STAFF RECOMMENDATION
210 Mockingbird Road
May 21, 2014

Application: New construction – infill and outbuilding
District: Cherokee Park Neighborhood Conservation Zoning Overlay
Council District: 24
Map and Parcel Number: 10312030000
Applicant: Michael Ward, Architect
Project Lead: Sean Alexander, sean.alexander@nashville.gov

Drawings:
 Front Elevation
 Rear Elevation
 Date:
 5.8.14

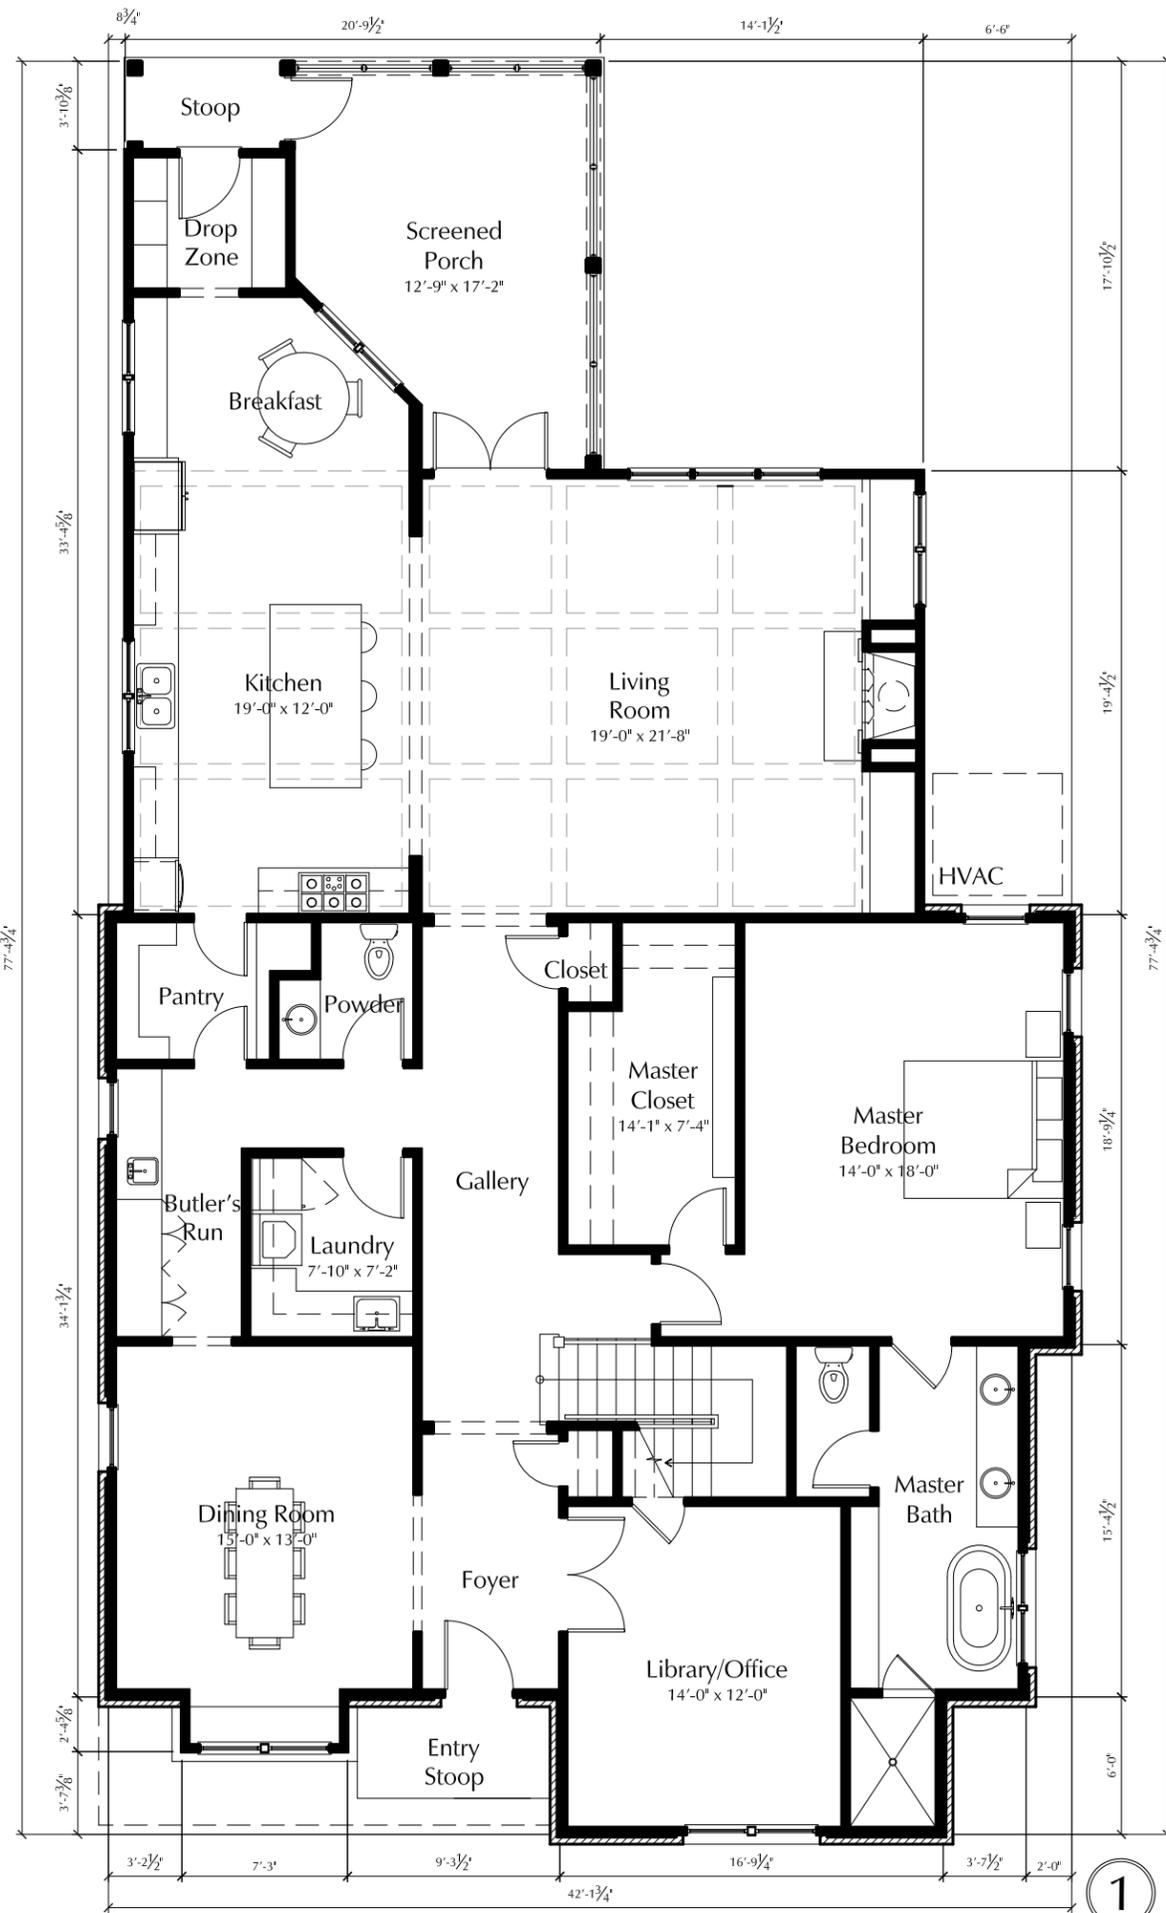
The house will be oriented with its front edge matching the orientation of other houses on the street. The new house will have a shallow entry stoop, four feet (4') deep and eight feet (8') wide, under a pent-roofed extension of the main front eave. Although smaller than the porches of most styles, the stoop is not unlike a shallow entry vestibule common to historic Tudor Revival houses.

The plans do not indicate any front paving. Historic houses in the area generally have a paved walkway leading from the house to the street or to a driveway at the side of the house. With either type of walkway added, staff finds that the project would meet guideline II.B.1.f.

1. The chimney material, brick color and texture, and the roof color, are approved administratively;
2. The windows and doors are administratively approved prior to final selection;
3. A walkway is added from the entrance to the front of the lot or to the driveway;
4. The location of external HVAC units are approved administratively.

Drawings:
Garage Plan
Garage Elevations
Date:
5.8.14

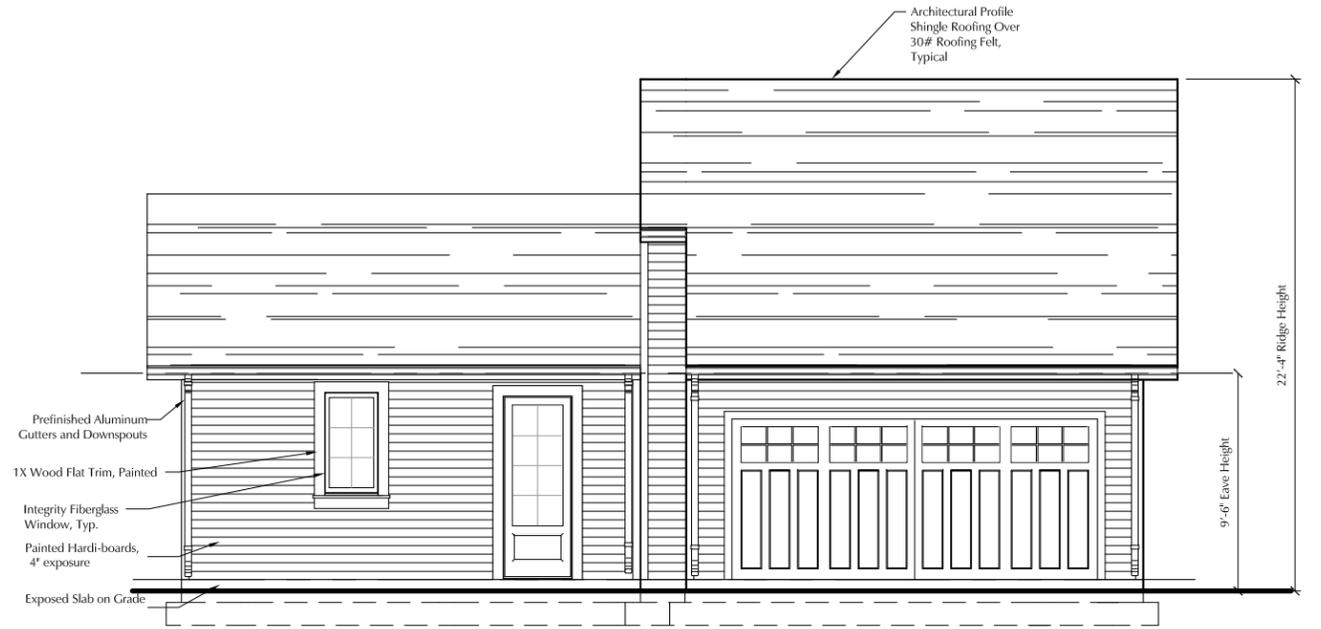
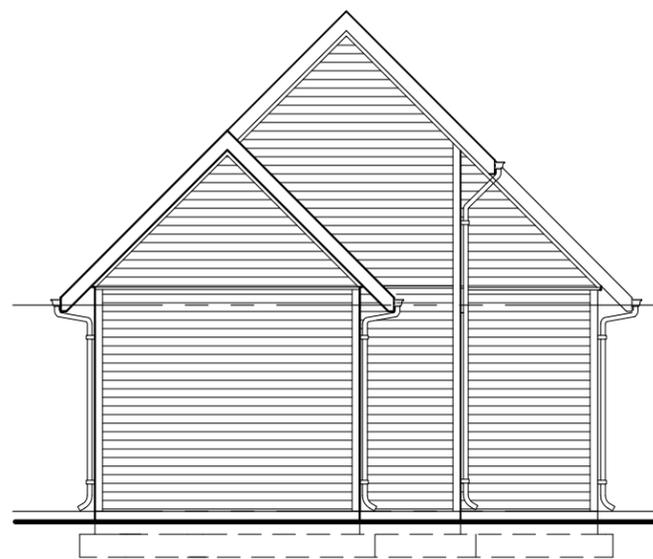
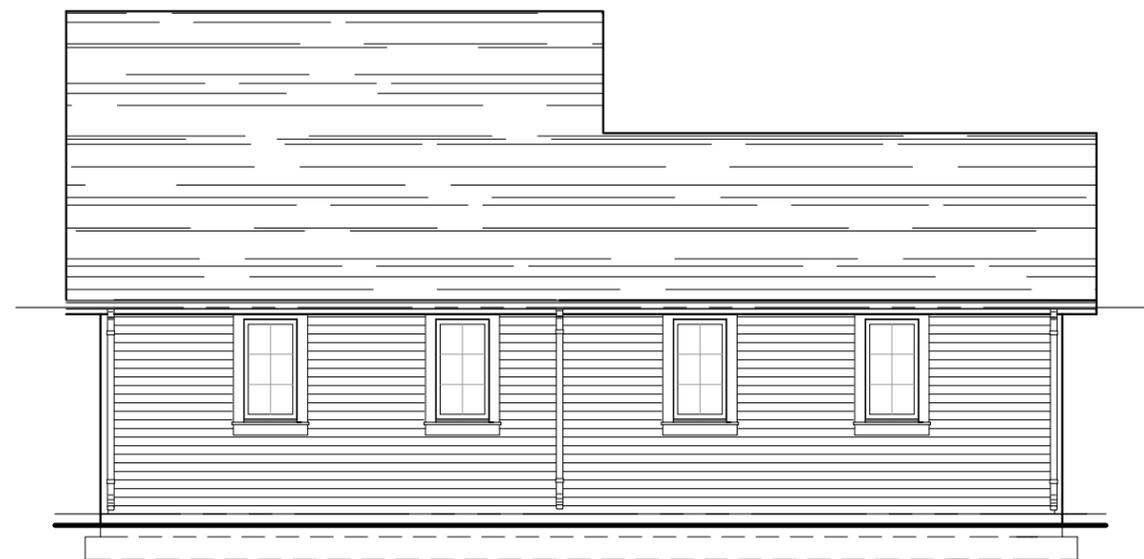
The project will also include a new outbuilding. The building will be one story with a two-car garage and workshop. The garage portion of the building will have a gabled roof with a peak height of twenty-two feet (22'), which will step down to seventeen feet (17') over the workshop. The building will be located eight feet (8') from the rear of the property and six feet (6') from the left side property line, accessed by the existing shared driveway. This location is compatible with surrounding outbuildings in the area, and meets the standard setbacks for a building with a footprint of seven hundred square feet (700 s.f.) or less. The primary cladding of the outbuilding will be cement-fiber siding, but it will otherwise match the primary building in materials, roof form and pitch, and general character. Staff finds that the outbuilding will meet section II.B.1.h of the Cherokee Park design guidelines.
